Subject **Response to Public Comments – Environmental Act Licensing - File 6013.10  
Rural Municipality of Springfield Well Field Expansion**

Subject **Response to TAC Comments – Environmental Act Licensing - File 6013.10  
Rural Municipality of Springfield Well Field Expansion**

Friesen Drillers is pleased to provide this letter in response to the commentary that was provided by the Technical Advisory Committee for the Environmental Act License of the above noted project. In particular this letter is focused on the comments provided by the Groundwater Management section on September 26, 2025.

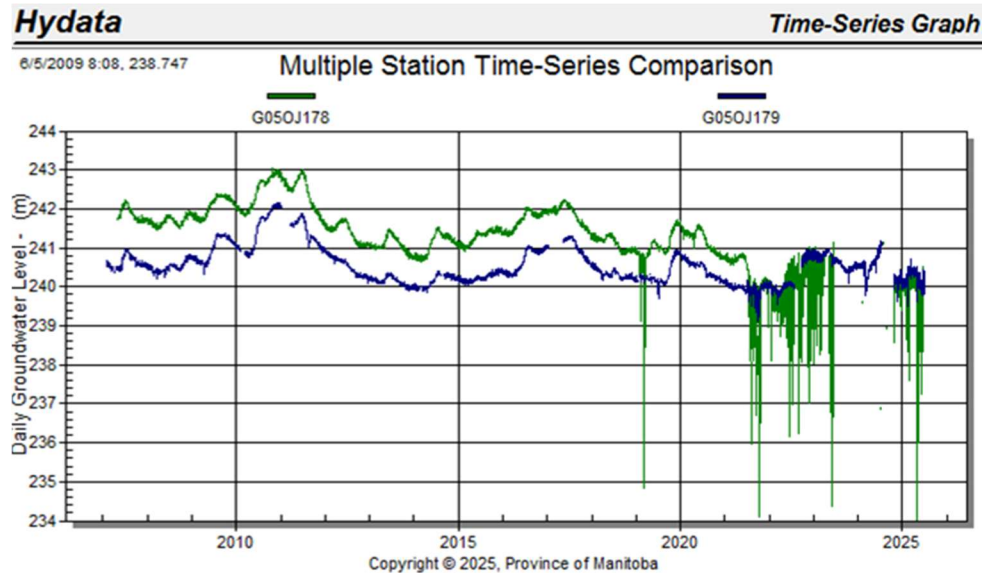
[page 56 – 13.2] Hydrograph data from provincial wells completed in both the sandstone and carbonate aquifers (OJ178 and OJ179) show that the groundwater level response in the carbonate aquifer at OJ179 is significantly greater than 5% of the drawdown in the sandstone, especially during periods of municipal pumping. The attached hydrograph of both demonstrates that cumulative impacts in the carbonate aquifer may be much greater than concluded in the report, particularly in the context of future, long-term operations. In addition, the time-series comparison of groundwater levels at stations G05OJ178 and G05OJ179 clearly shows a persistent head difference (gap) between the two aquifers prior to 2021, reflecting the confining effect of the intervening shale layer. However, since mid-2021, this head gap has largely disappeared, with groundwater levels in both aquifers converging and fluctuating together. This loss of head separation strongly suggests that the confining effect has been compromised, most likely due to increased municipal pumping. As a result, the hydraulic connection between the sandstone and carbonate aquifers has been enhanced, allowing pumping impacts to rapidly transmit between both units

The carbonate aquifer and the underlying sandstone aquifer appear to be performing in a parallel manner, with a slight head difference. This is present in many areas of the southeast. As noted in page 26 of the report, there are many examples of interconnection in the two bedrock aquifers in Manitoba.

In the hydrographs for the two wells, we see that prior to 2021 the potentiometric level in the Sandstone Aquifer was about 1 m higher than the potentiometric level in the overlying Carbonate Aquifer. Pumping from the Sandstone Aquifer appears to have begun in 2021 and the non-pumping potentiometric level declined to the level in Carbonate Aquifer [the potentiometric level in the Carbonate Aquifer continued to fluctuate within its historical range]. In effect, the tendency for groundwater to flow upwards from the Sandstone to the Carbonate Aquifer was neutralized by the change in head difference. This should not be interpreted as an enhancement of the hydraulic connection between the two aquifers, which is a physical reality of the geology. Rather, the effect of pumping is to reduce the rate of upward leakage from the Sandstone into the Carbonate Aquifer. If the Carbonate Aquifer is pumped, a negative local vertical hydraulic gradient will likely be re-created.
